TECHNICAL SERVICE BULLETIN

POWER DOOR LOCK INTERFACE MODULE CONNECTION

NO.	TSB-90-00-007
DATE	December, 1990
MODEL	All

Figure 1

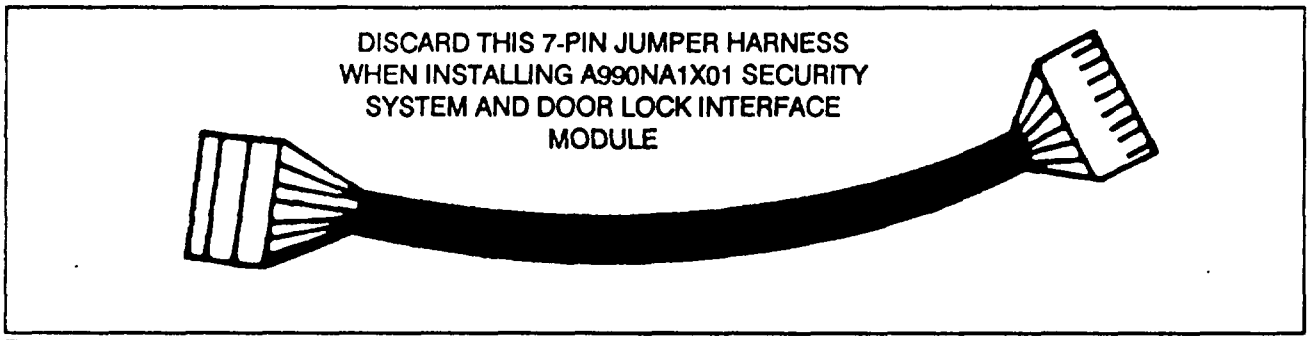
Included in the Power Door Lock Interface Module (A999NC1X01) kit is a 7 Pin jumper harness assembly. This jumper harness is not used with the new Triple Diamond Vehicle Security System (A990NA1X01) only with the old systems (A998NA1X01 and A998NA1X02). When installing the new security system AND a door lock interface module, discard the jumper harness (Figure 1). Connect the 7-pin connector from the security system module to either connector of the power door lock interface module.
